Aylesham Centre

Environmental Statement Addendum

Volume 2: Heritage, Townscape and Visual Impact Assessment Addendum

- 1.3 An ES Review was provided by LUC in November 2024 (the ES Review Report being dated October 2024), responses to the clarifications raised in LUC's ES Review are presented in Table 1.1 below.

Panorama 2: Norwood Park to the City

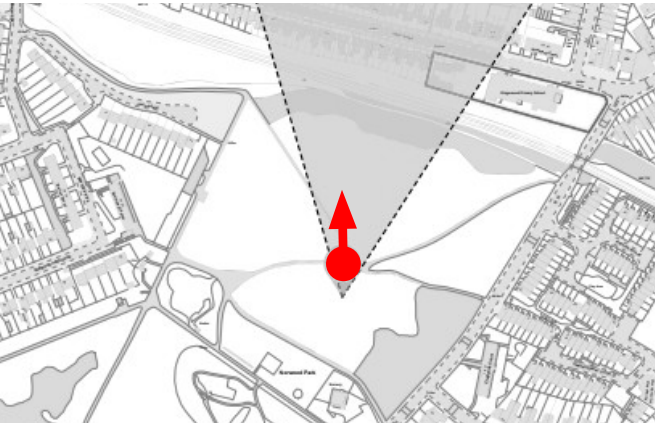
London Borough of Lambeth (LBL) Comments LBL requested to see three Lambeth local views in order to make their assessment, these view locations are specified within the emerging Lambeth Local Views SPD, and LBL considered that the Proposed Development would sit within the view cones of the three views.	Three views from within Lambeth were requested for testing by LBL in the post-submission period. These are views identified in their emerging Lambeth Local Views SPD, namely: - Panorama 1C Brockwell Park to the City - Panorama 2 Norwood Park to the City - Panorama 3 Gipsy Hill to the City The three views were tested using 3D London software ‘Vu City’, into which the architectural model provided by the architects dRMM had been inserted. This testing showed that: In two of the views (Panorama 1C Brockwell Park; and Panorama 3 Gipsy Hill), the Proposed Development would not be visible at all, since it would be occluded behind intervening townscape elements. In the images provided, the red outline of the scheme is included to show its hidden position. In the view from the high ground of Norwood Park (Panorama 2 Norwood Park), the Proposed Development would be visible but is located significantly east (to the right, when seen from the viewpoint) of the principal aspect of the view towards the City cluster of tall buildings to the north. In the Vu City image provided the Proposed Development is shown in pink, and when focussing in on the view, it can be seen as part of the ‘foot hills’ of the taller buildings consented and under construction in the Old Kent Road area beyond. These buildings are shown in yellow and blue in Vu City. It is considered that the proposal sits entirely appropriately into the emerging panorama and would not produce an additional significant visual effect from this viewpoint.

- 4.1 Three views from within Lambeth were requested for testing by LBL in the post-submission period. These are views identified in their emerging Lambeth Local Views SPD, namely:
- Panorama 1C Brockwell Park to the City

• Panorama 3 Gipsy Hill to the City
- 4.2 The three views were tested using 3D London software 'Vu City', into which the architectural model provided by the architects dRMM had been inserted. The following pages show those views in the cumulative condition. See table 1.2 within the HTVIA Addendum chapter for the assessment undertaken.

Figure 5.1: Cumulative Schemes Map

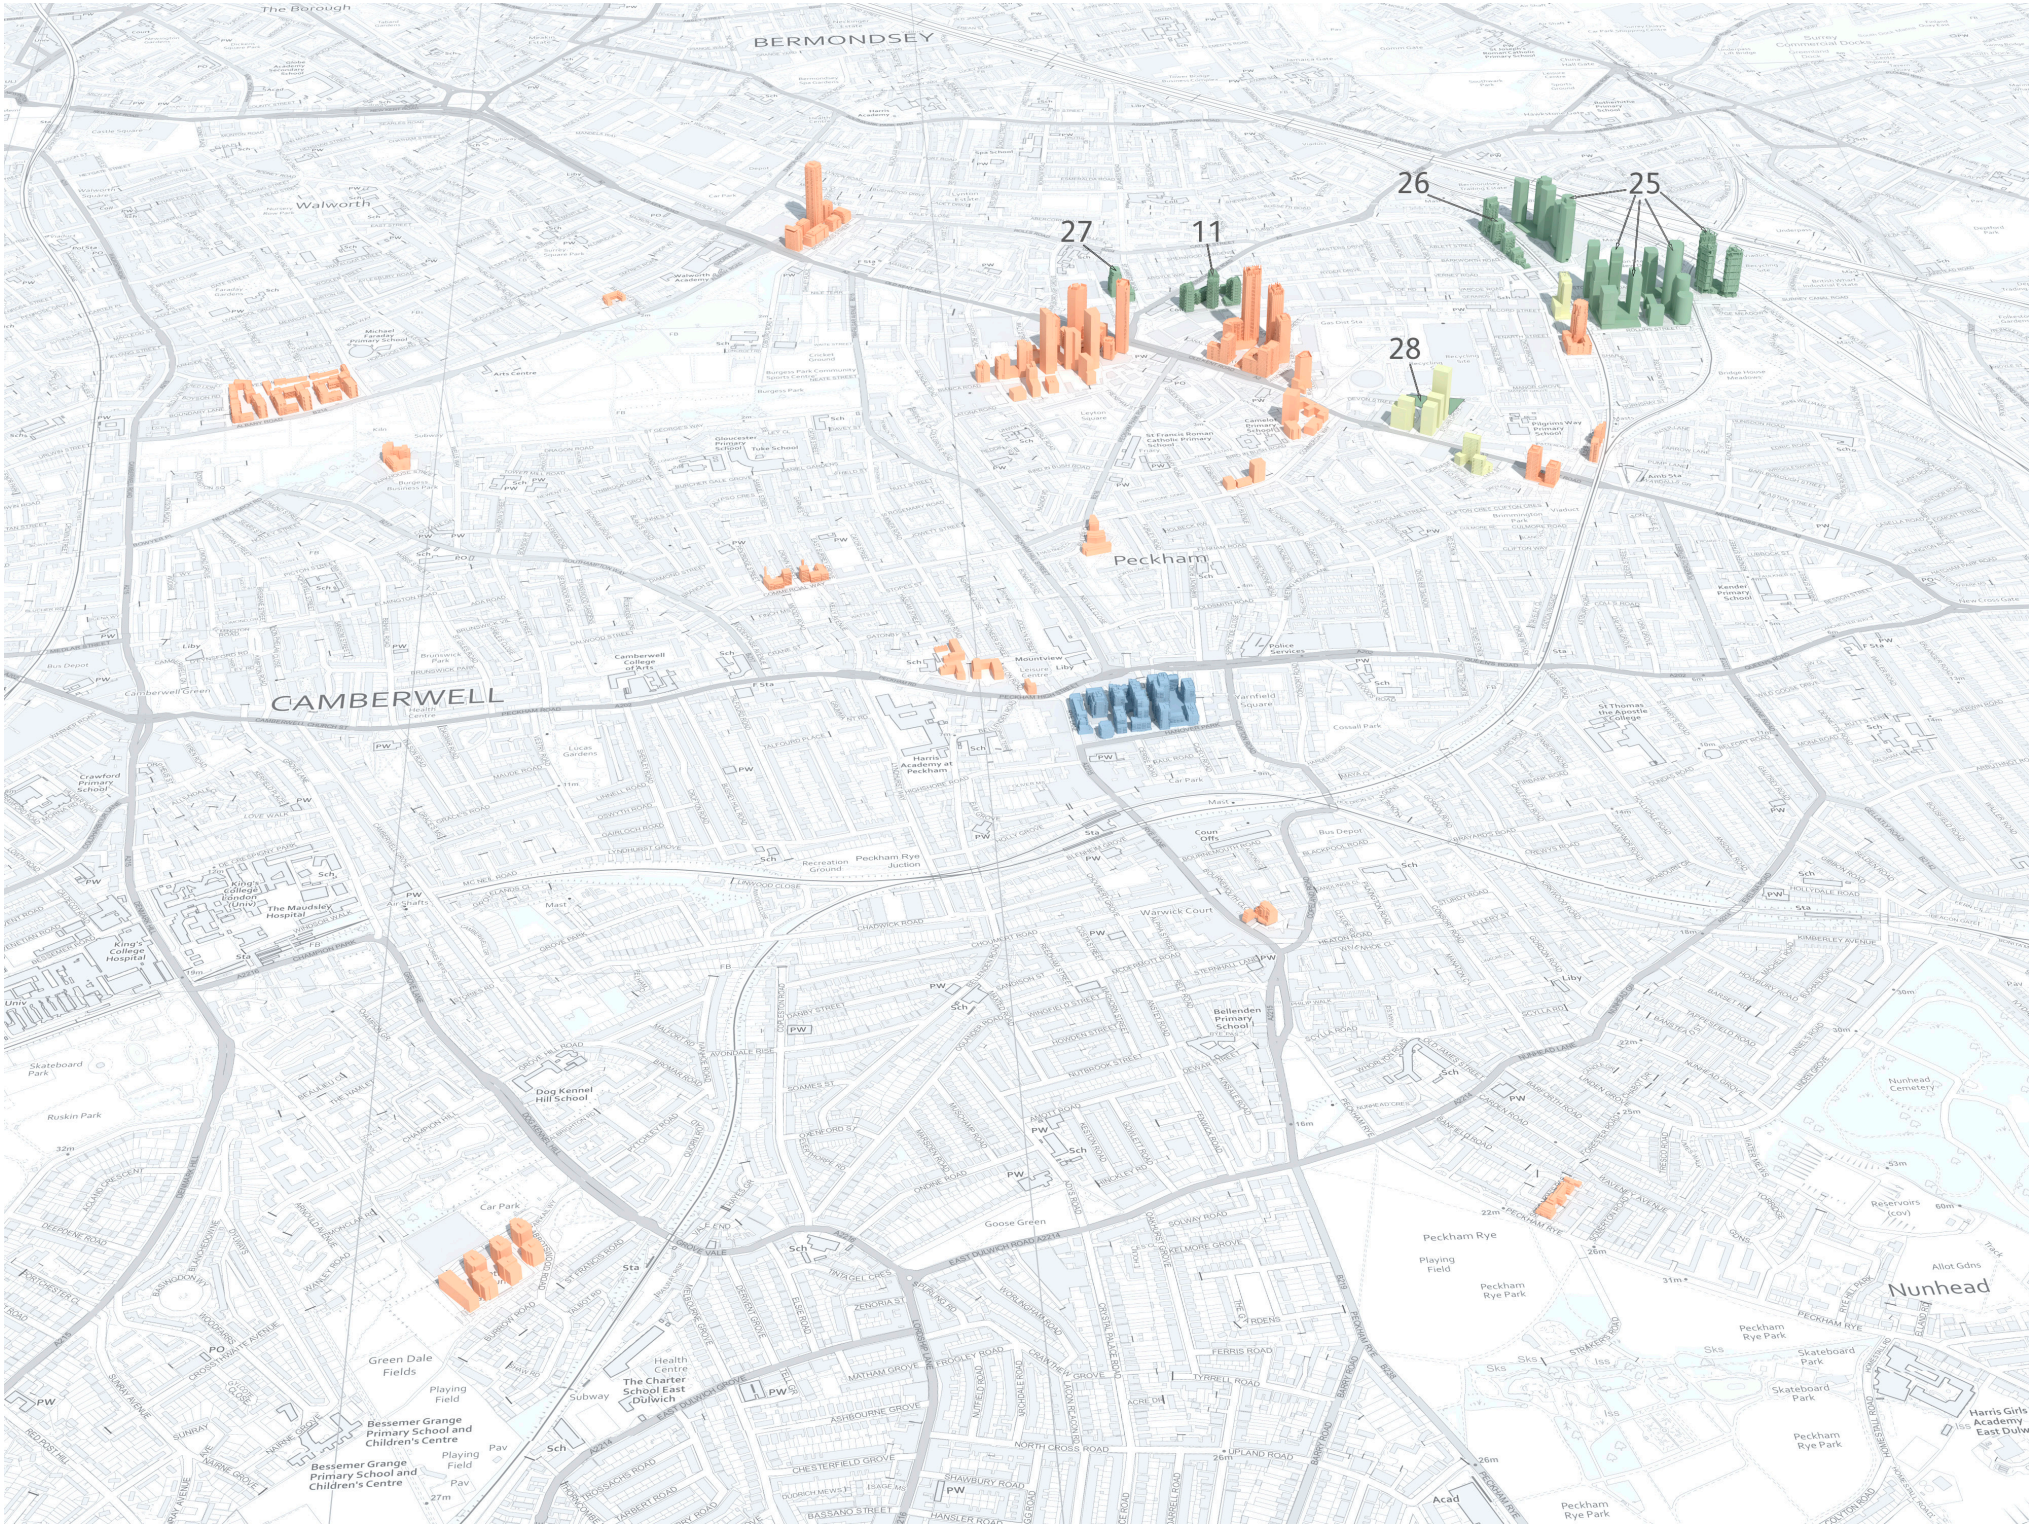
- 1.29** From other elevated viewpoints, (views 30, 31, 32 and 33 for example) looking more directly northwards, visual receptors may experience some minimal visibility of new schemes 11 and 27 (6-12 Verney Road London SE16 3DH and 310-330 St James's Road London Southwark SE1 5JX) alongside the cumulative schemes already included in the July 2024 HTVIA. These additional cumulative schemes are smaller in scale and will likely be partly occluded by the July 2024 cumulatives or the Revised Proposed Development itself. New cumulative schemes 25 and 26 are located further to the east and would be separate and visually distanced from the Revised Proposed Development and therefore would not lead to any material additional cumulative effects, whether in respect of heritage, townscape or visual receptors.

- 1.30** It was not considered proportionate to update the submitted AVRs to include the additional cumulative schemes identified.
- 1.31** In summary, there are considered to be no material changes to cumulative effects, and therefore the conclusions of July 2024 ES HTVIA chapter remain robust and valid.
